**CITY OF LOS ALTOS
CITY COUNCIL MEETING
July 28, 2015**

Agenda Item # 9

SUBJECT: Introduce and waive further reading of Ordinance No. 2015-411, rezoning the property at 366 First Street (Draegers' Market) from Downtown Commercial/Multiple-Family (CD/R3) to Commercial Retail Sales (CRS); and approve Design Review 14-D-03, Variance 14-V-15 and Use Permit 14-UP-04 applications subject to the findings and conditions

SIGNAGE DETAILS

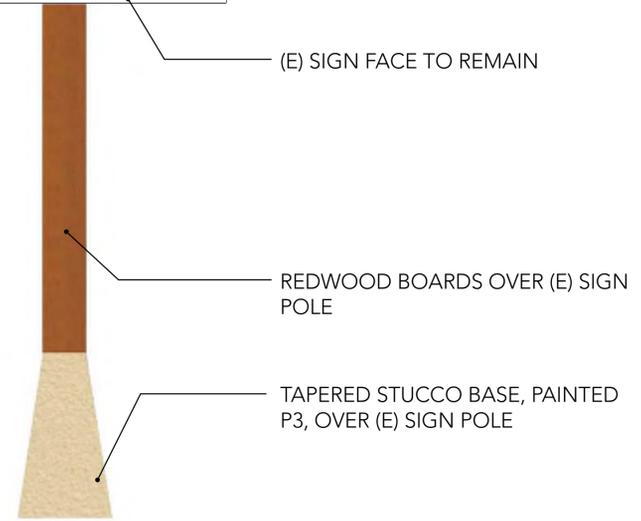
Per the Commission agenda report recommendation, the design of the existing pole sign has been updated (Sheet 13). The pole sign face will remain, but the sign will now include a stucco base and be clad with redwood trim to match the design of the building. To address replacement of the five existing loading zone spaces along First Street, it is recommended that the three new on-street spaces south of Whitney along the project frontage be designated as loading between the hours of 5:00 a.m. and 11:00 a.m. (Condition No. 3). Since the capacity of the loading bay is being expanded and large delivery trucks will no longer need to use the street, it appears that three loading zone spaces will adequately meet the needs of the grocery store.
